#2022-20
LES / JAIL FOOTINGS AND FOUNDATIONS
FOR
FACILITIES MANAGEMENT
ROCK COUNTY, WISCONSIN

BID PACKAGE #1 - ADDENDUM No. 1

PROJECT NAME: Rock County LES/Jail
Janesville, Wisconsin

PROJECT NUMBER: 210011.00

Sheet Number
S1.12

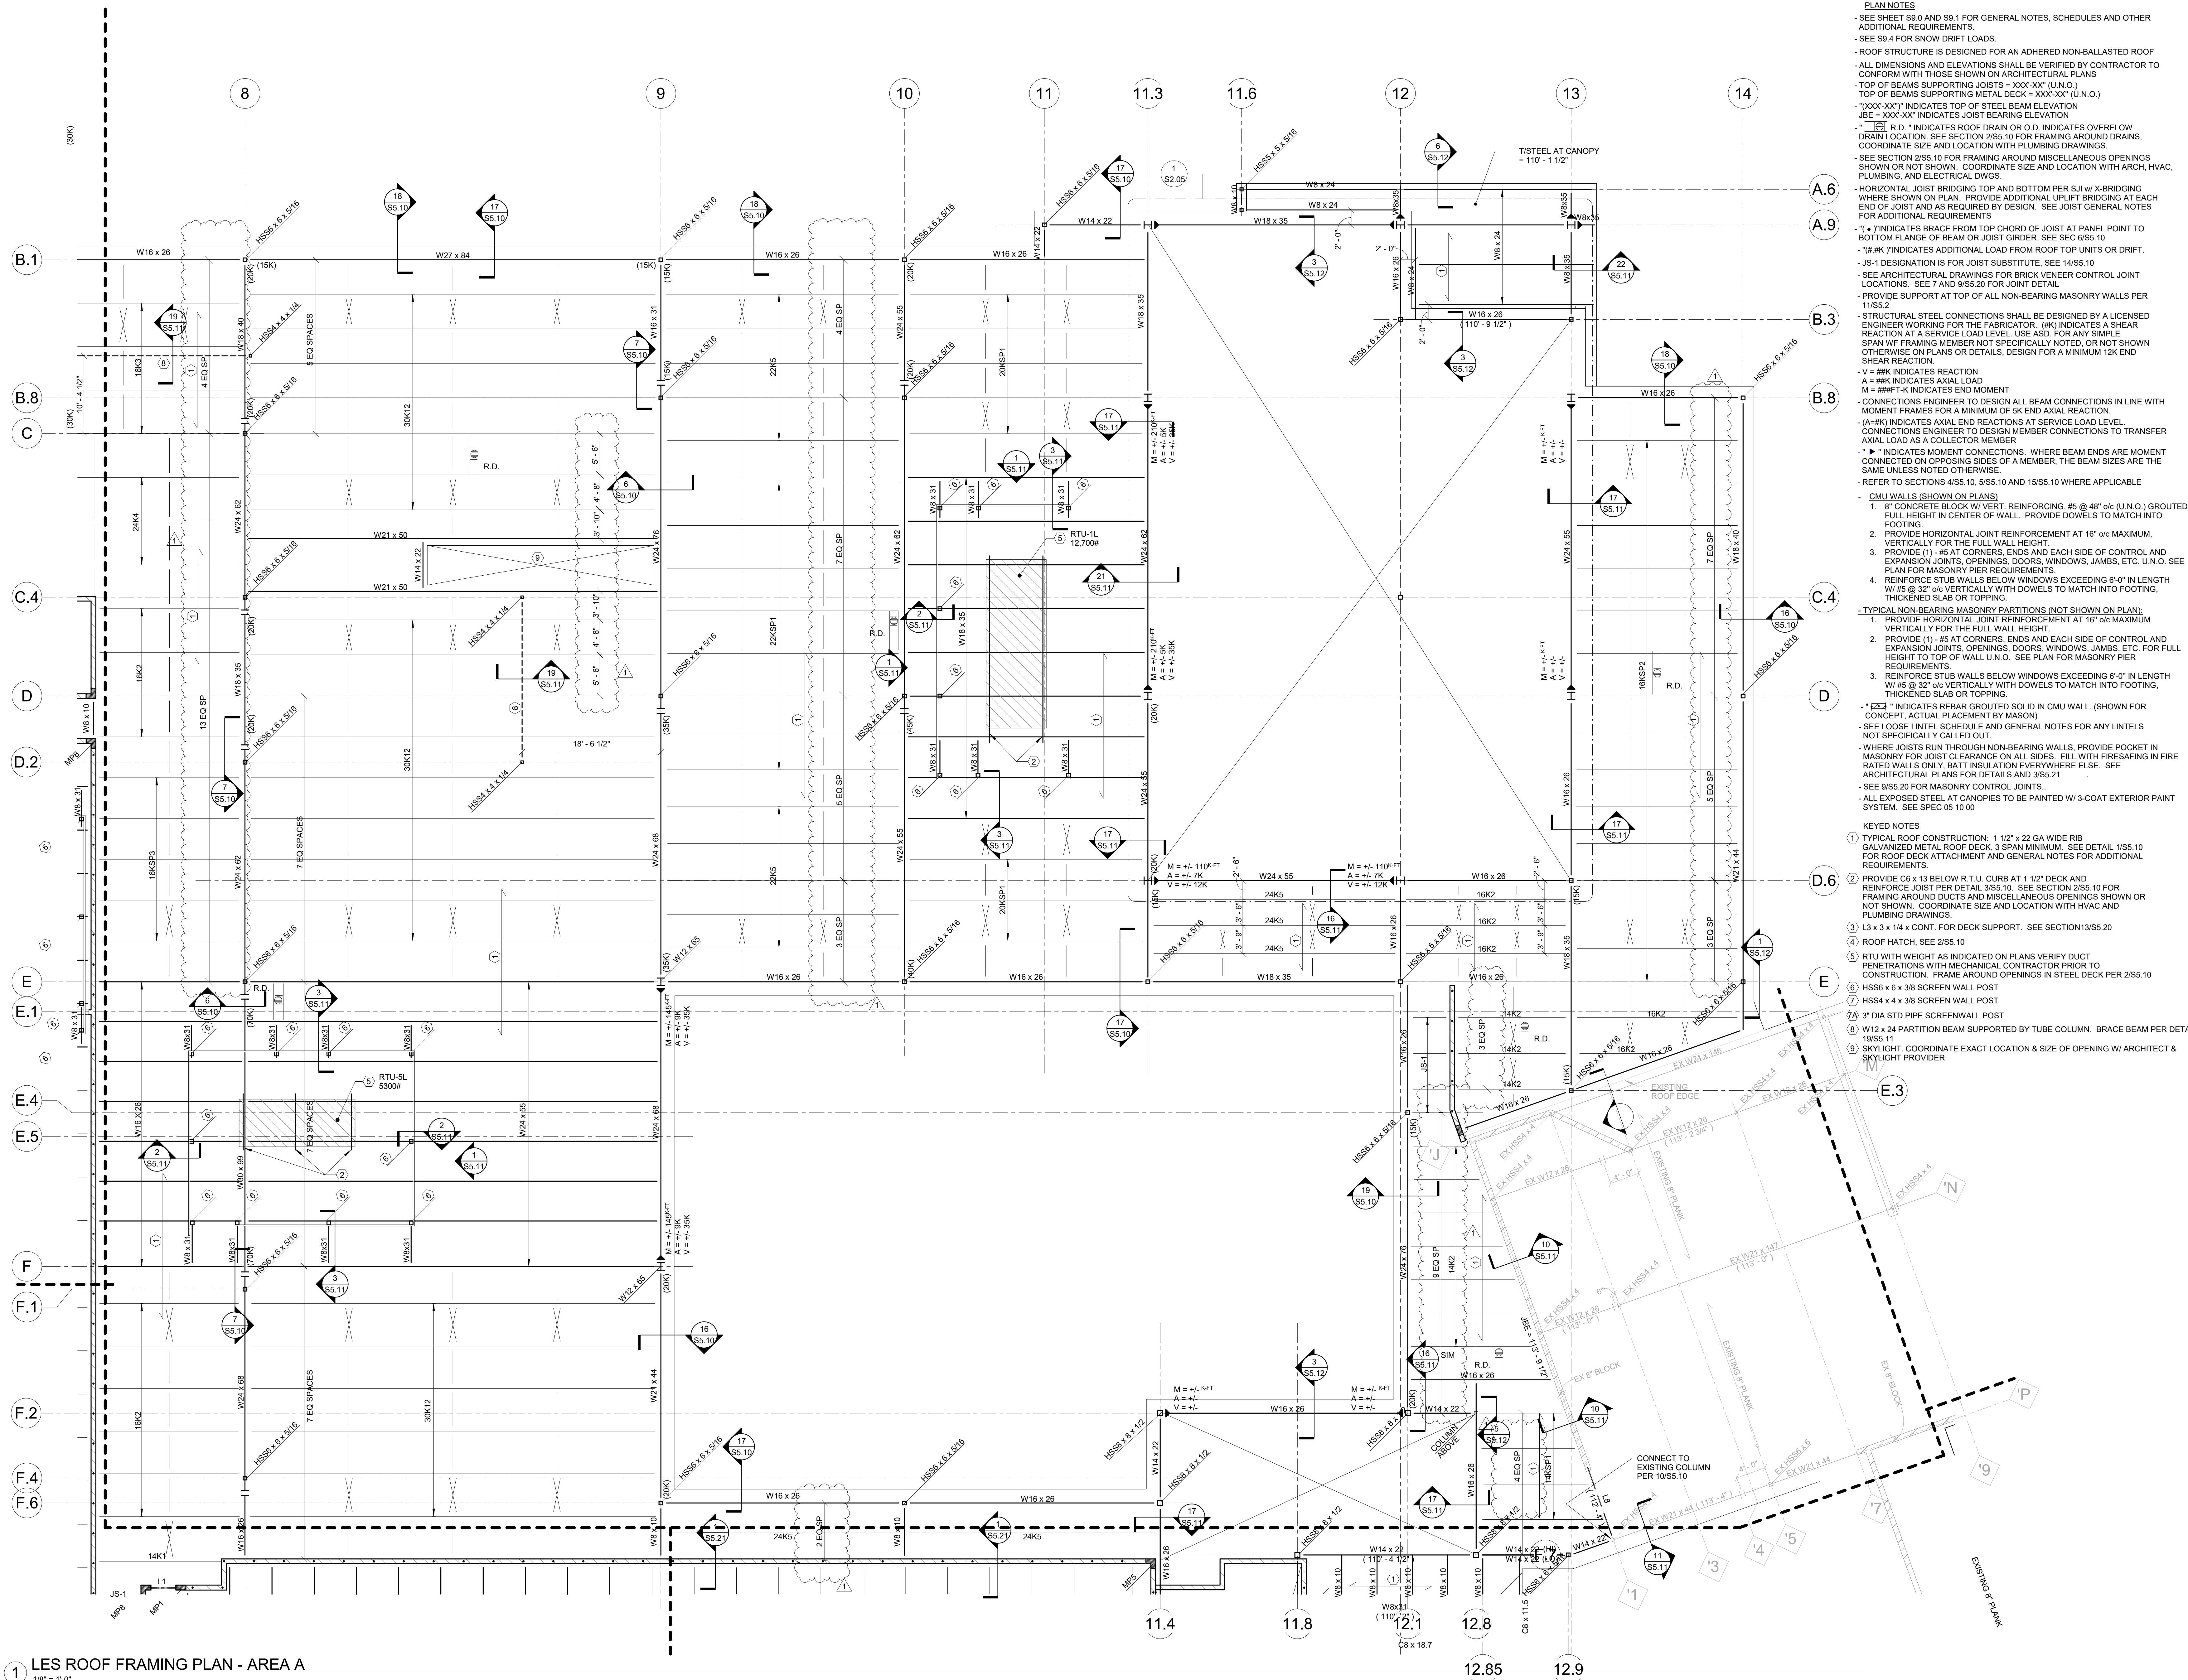
- b. ADD embed plates (keyed note 10) along A between 3 and 7
- 8. Sheet S1.12 Jail Foundation Plan – Area F
 - a. ADD footings to several areas
 - b. ADD / MODIFY footing elevations and steps at various locations

- c. MODIFY footing size at Classroom area
- 9. Sheet S1.14 Jail Foundation Plan – Area H
 - a. Add underpinning note
 - b. MODIFY grade beam along grid EB

Graphic Scale	
Project Number	210011.00
Set Type	CD
Date Issued	3/22/2022
Sheet Number	S2.12

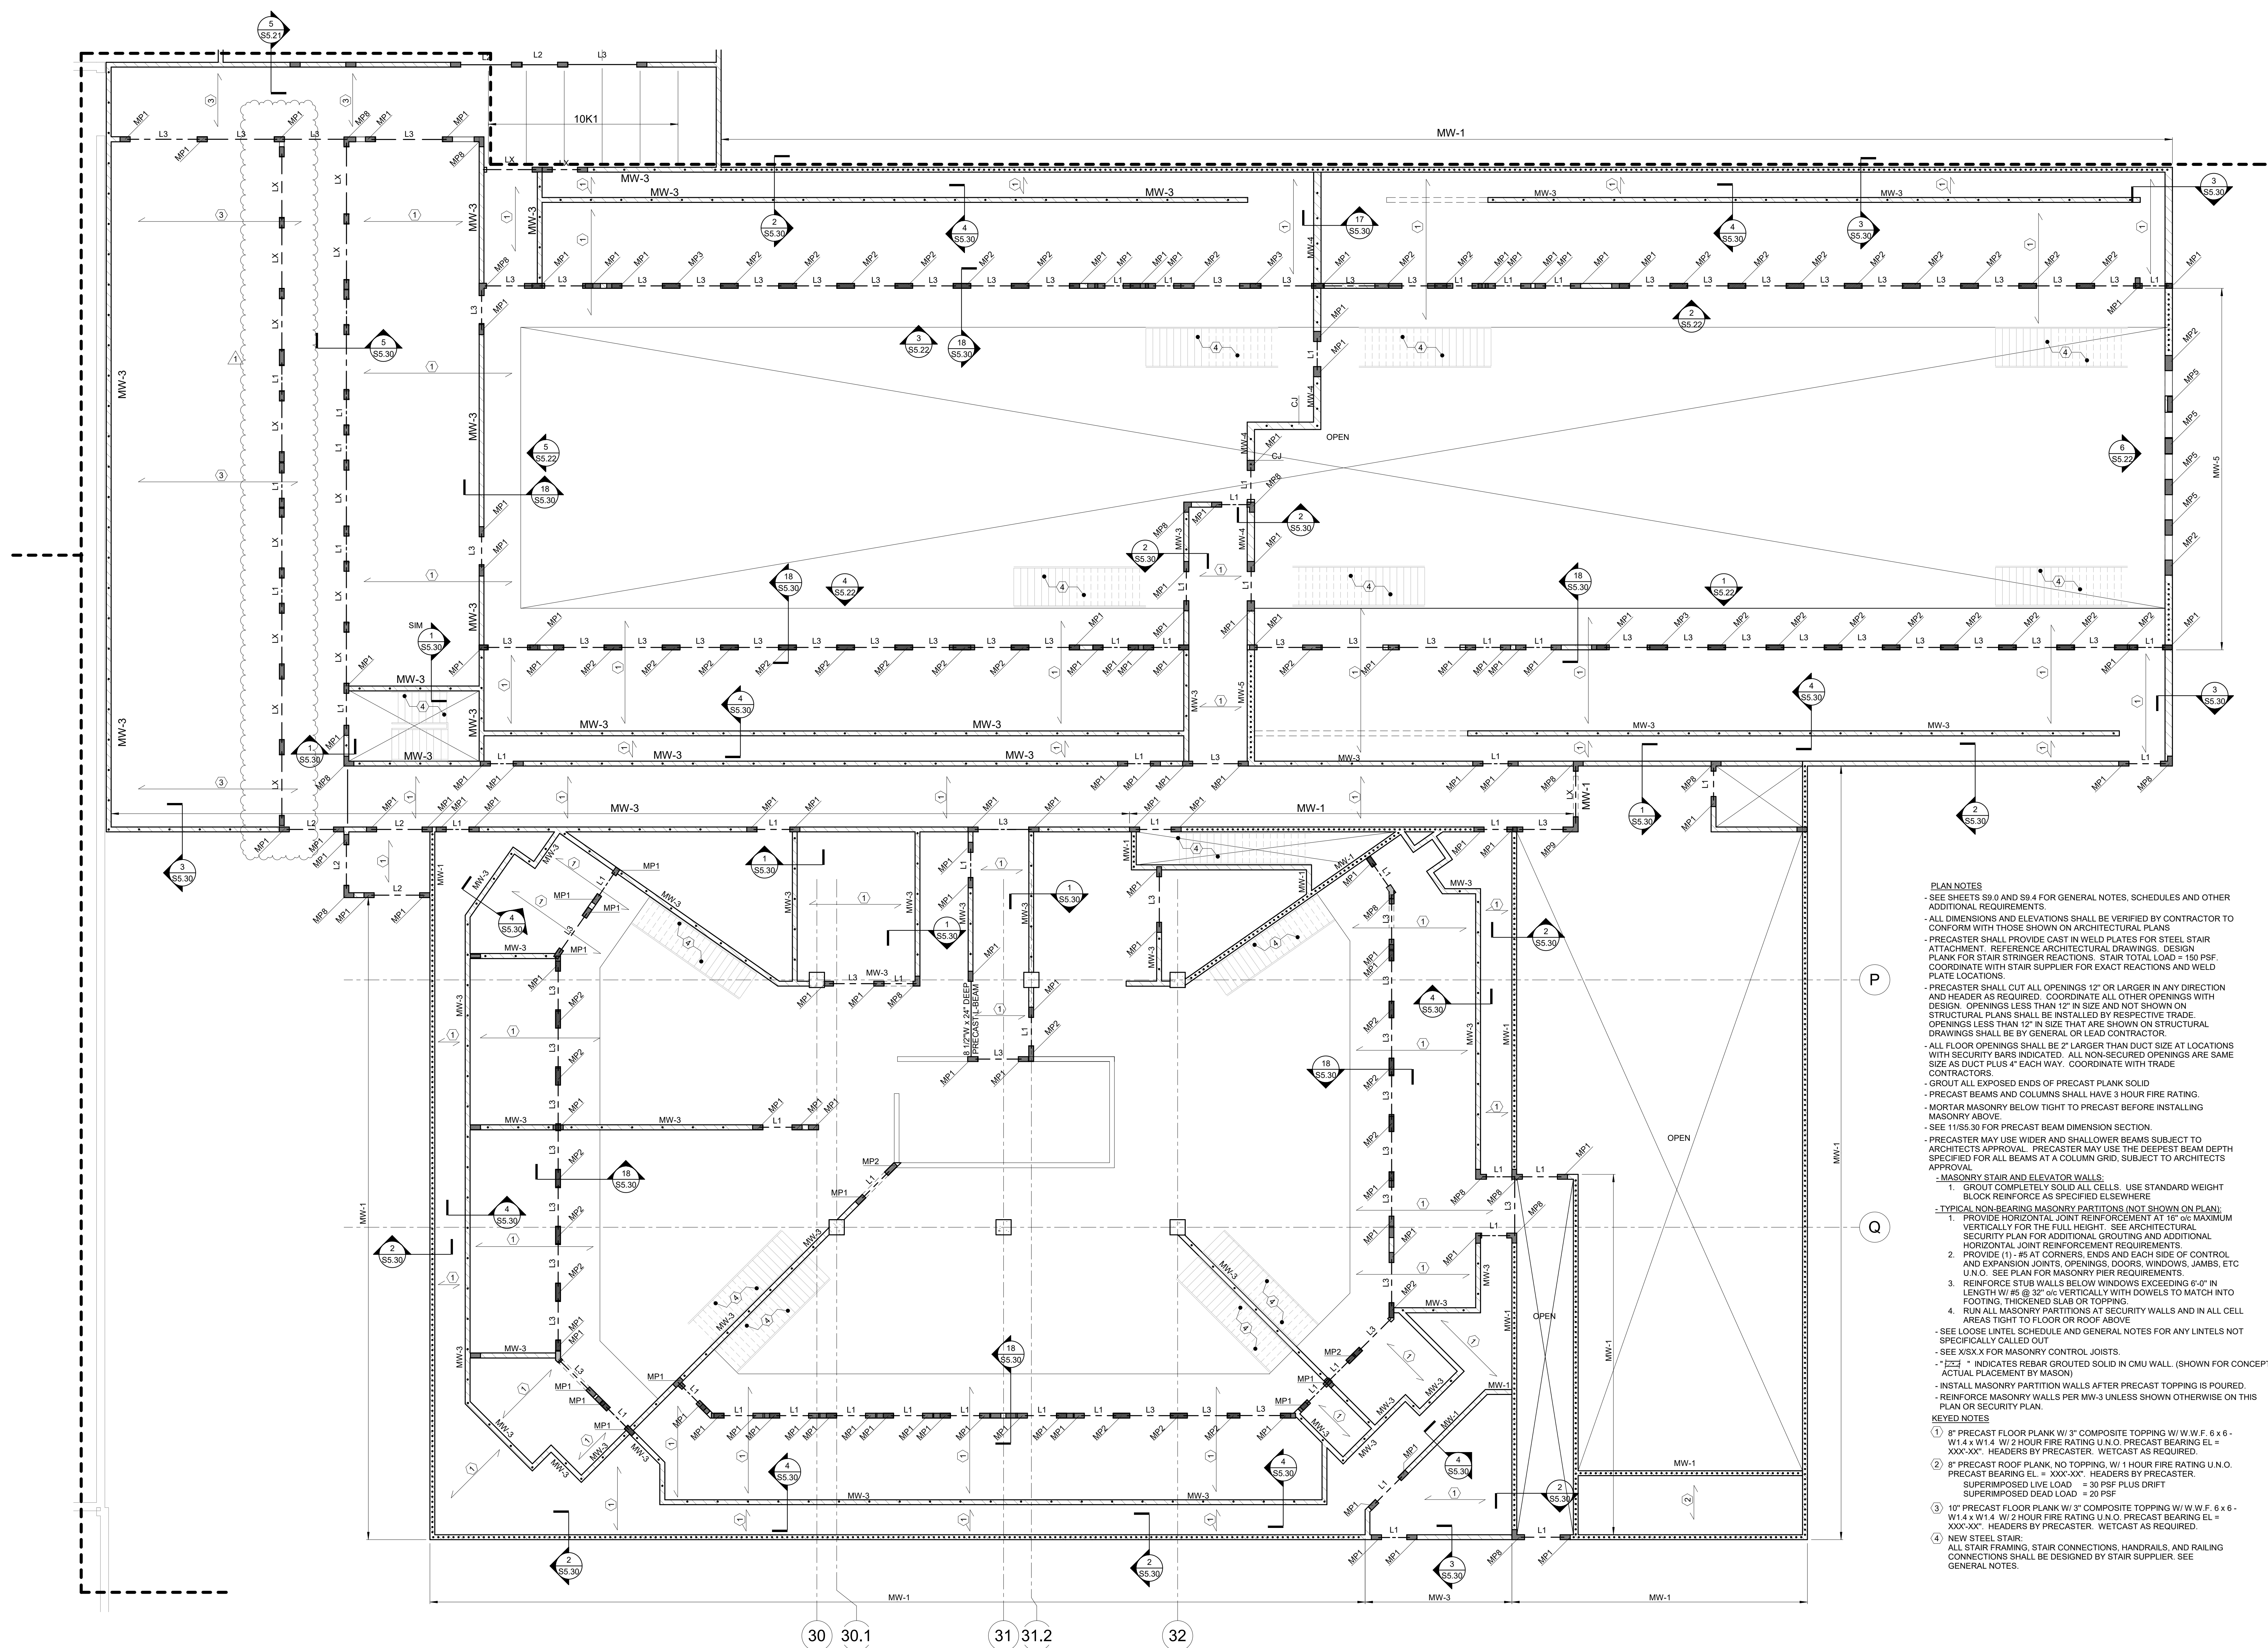
- c. ADD 7: Canopy Plan
- 15. Sheet S2.11 Jail Roof Framing Plan – Area E
 - a. MODIFY clerestory framing
- 16. Sheet S2.12 Jail Floor Framing Plan – Area F

- a. MODIFY floor framing at Mechanical mezzanine
- 17. Sheet S2.13 Jail Roof Framing Plan – Area G
 - a. MODIFY vestibule framing to delete joist
- 18. Sheet S5.1 Details

5 RETAINING WALL

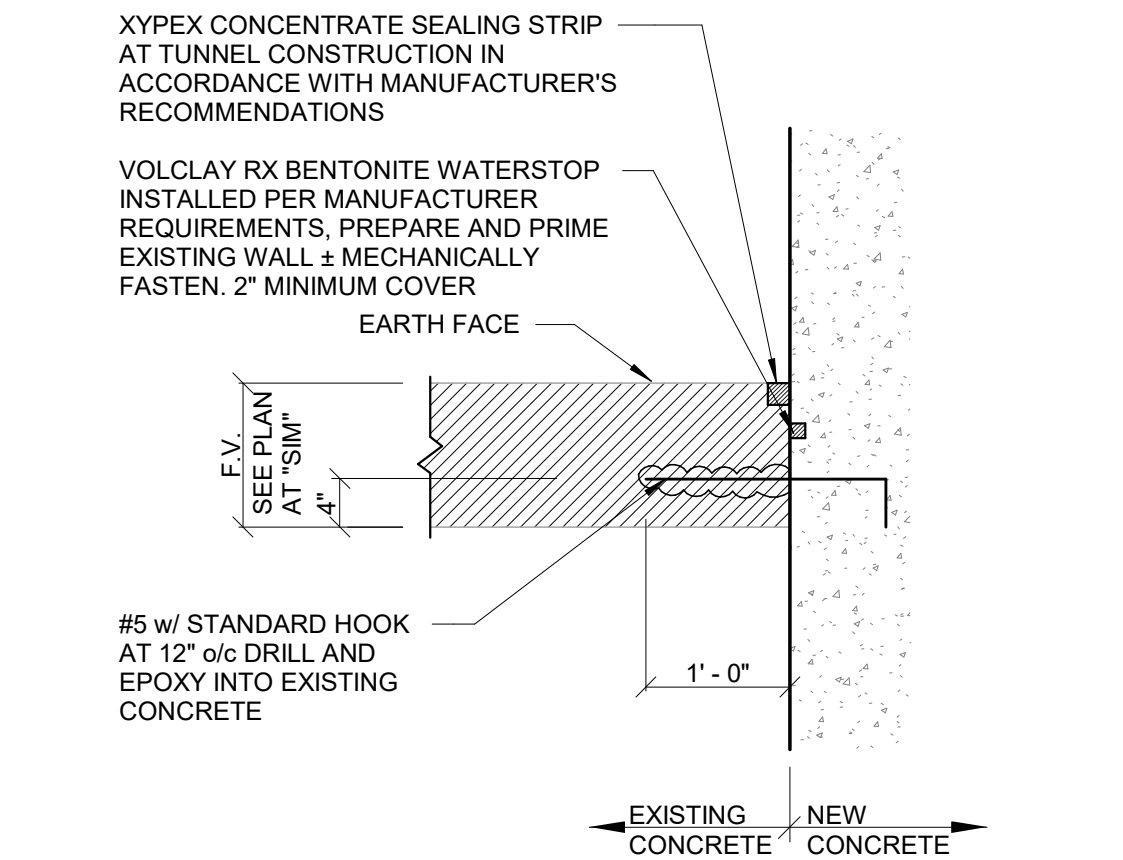
- a. MODIFY key depth on detail 5
 - b. MODIFY note on detail 12
 - c. MODIFY note on detail 16
 - d. DELETE detail 18
 - e. MODIFY elevations on detail 19
